KEENE PLANNING BOARD
Council Chambers, Keene City Hall
May 26, 2026
6:30 PM

1. **PB-26-10 - Habitat for Humanity Duplex, Cottage Court Conditional Use Permit** — Applicant SVE Associates, on behalf of owner Monadnock Habitat for Humanity, proposes to construct a 1,364 sq-ft duplex at the property located at 0 Grove St. (TMP# 585-057-000). The parcel is ~.11 ac and is located in the Residential Preservation District.

PLANNING BOARD
MEETING MINUTES

Figure 2. A snippet of the proposed conditions plan showing the proposed layout of the duplex at Grove St.

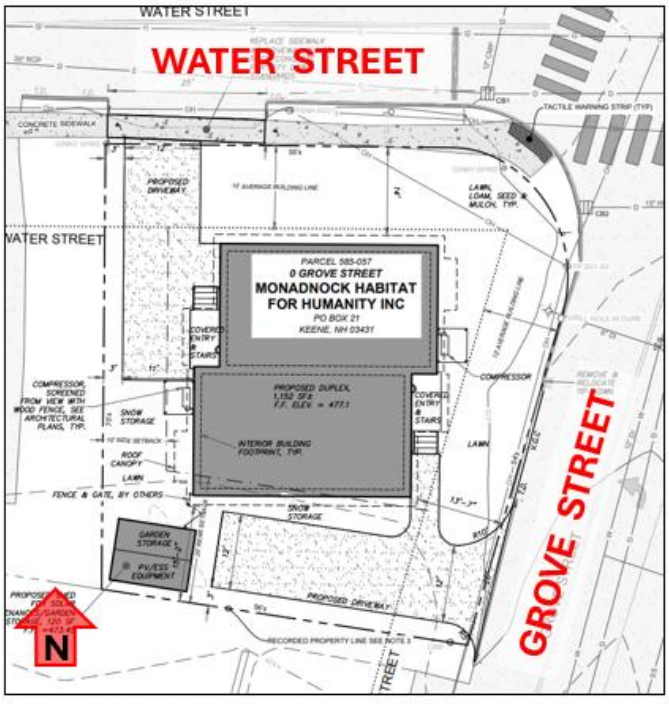
17.4 **Permitted Uses:** The proposed duplex is allowed in the Residential Preservation District with a Cottage Court Conditional Use Permit. An accessory shed is proposed in the southwest corner of the site to house mechanical equipment and provide storage areas for tenants (Figure 2). This standard appears to be met.

17.5.2 Dimensional Standards: The applicant proposes to construct a 2-story duplex on a corner lot with frontage on Water St and Grove St. The proposed front setback is just over 13-ft and the corner side setback is just over 12-ft. Although this does not comply with the 15-ft front setback and the 20-ft corner side setback required in the Residential Preservation District, Table 17-2 in the LDC allows Cottage Court Developments additional flexibility with setbacks from external roads, stating that, "*Setbacks from existing roads external to the development may be less than the underlying zoning district in order to match an established building line along the road.*" The applicant submitted an exhibit showing the average building setback distances along both Water St and Grove St which shows that, based on the existing development pattern in the neighborhood, the front setback could be reduced to ~13-ft and the corner side setback could be reduced to ~12-ft.

Figure 2. A snippet of the proposed conditions plan showing the location of the delineated wetlands and 30-ft surface water buffer on the parcel at 30-42 Production Ave.

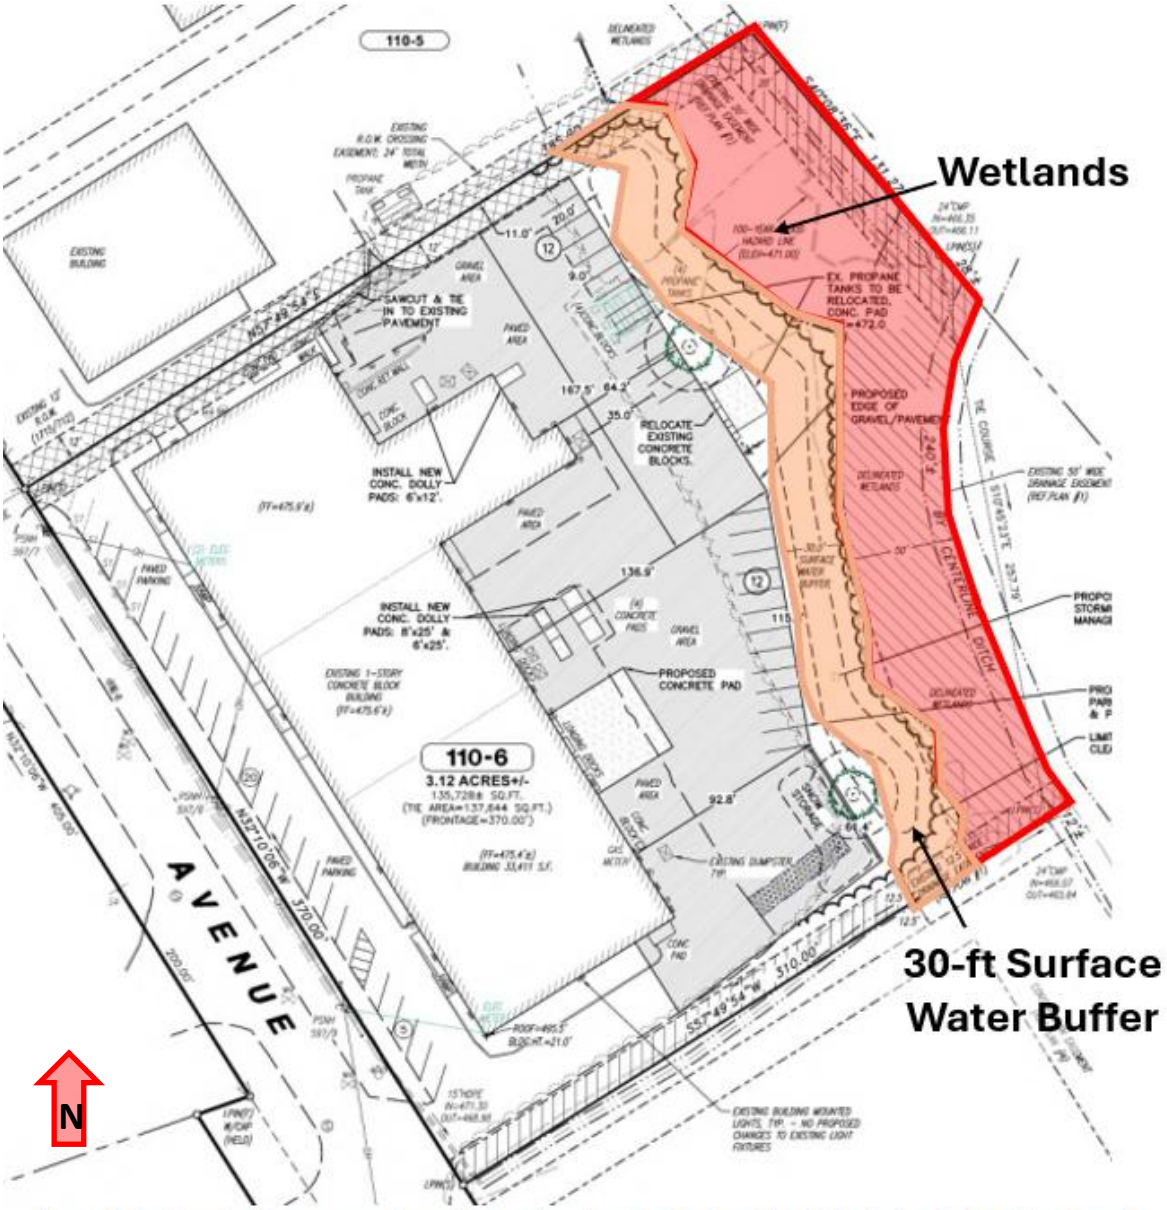
2.A **Relocation of Proposed Use / Activity:** The applicant proposes to formalize and expand the rear parking area by adding 24 additional parking spaces. The expanded parking area will provide more space for tenants to accept deliveries by large trucks and solve existing drainage issues. The parking lot is designed to pitch to the rear of the lot into a detention basin at the back of the building. The site is bounded on its eastern side by an area of wetlands, which run parallel to the City's tax ditch. Figure 2 shows the location of the wetlands in red and the 30-ft surface water buffer in orange.

2.D **<u>Preservation of Buffer</u>:** The narrative states that impacted portions of the surface water buffer will be replanted with water-loving plant species and a conservation seed mix will be used to stabilize the berm for the rain garden. Work within the tax ditch will be coordinated with the Public Works Department to ensure that impacted areas are only disturbed once. Planning Staff recommend that the Board include a condition of approval related to the submittal of a security to cover sediment and erosion control measures as well as all landscaping and seed mix needed to stabilize the rain garden.

Figure 2. A snippet of the proposed conditions plan showing the proposed layout of the development.

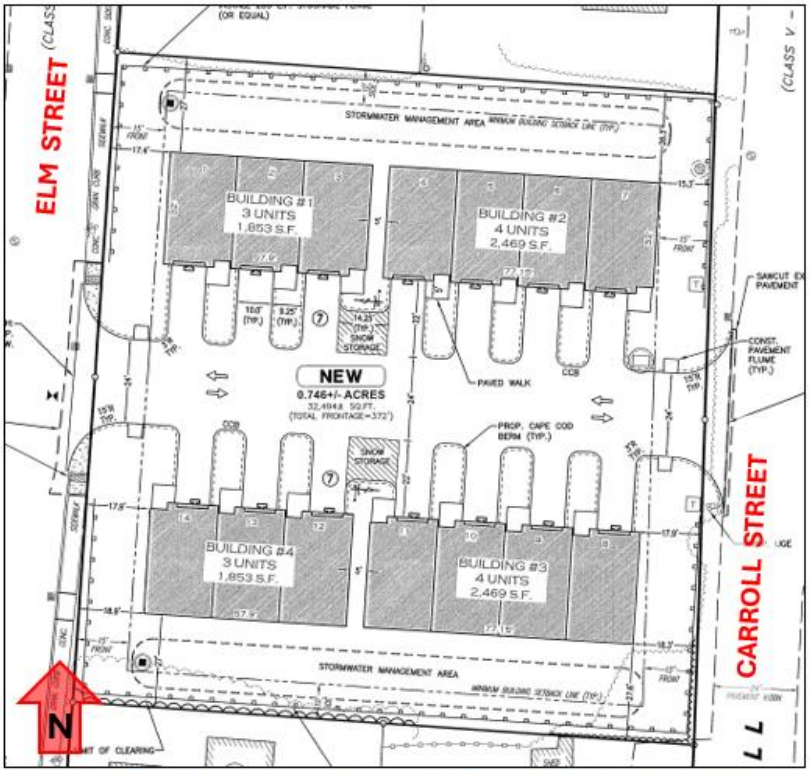
B. **Parking:** Cottage Court developments must provide at least one parking space per unit and no more than one parking space per bedroom. Each of the 14 units will have two bedrooms, therefore a minimum of 14 parking spaces and a maximum of 28 spaces are required. The plan shows 28 parking spaces – 1 in the garage for each unit and 1 in a surface-level parking space outside the garage (Figure 2). This standard appears to be met.

C. **Building Separation:** The narrative states that there will be a 5-ft separation between each building and exterior walls will be fire-rated to meet building and fire codes. This standard appears to be met.

D. **Driveways:** The applicant proposes a curb cut on Elm St and another on Carroll St. Each curb cut will be designed to accommodate two-way traffic with a 24'-wide vehicle travel aisle connecting both sides. They are proposed to be ~30'-wide at the curb line and ~52'-wide at the property line where a maximum width of 25' and 50' are allowed, respectively. Planning Staff are waiting to hear back from the applicant regarding how they plan to meet this requirement and will share updated information with the Board during the public hearing for this application.

Figure 3. Snippets from the submitted elevations showing the proposed designs for the front, side, and rear exterior building facades.

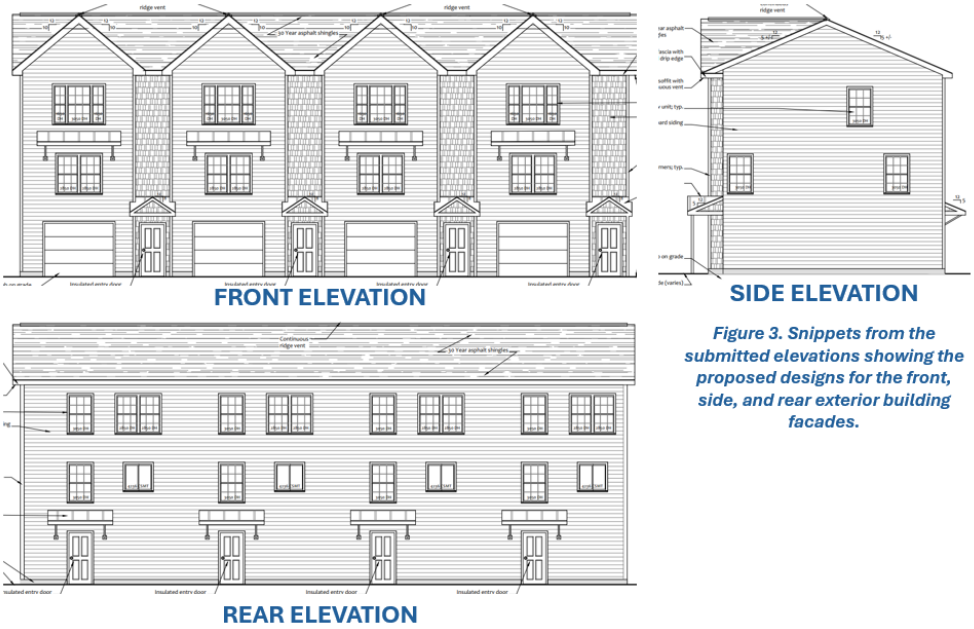
F. **Architectural Guidelines:** The proposed elevations show that the building exterior will be finished with a mix of horizontal vinyl siding and vinyl shake siding (Figure 3). The narrative states that the buildings will be finished with neutral colors that fit in other similar buildings in the neighborhood and around the City. The Board will need to determine if the applicant has satisfied the intent of this standard.
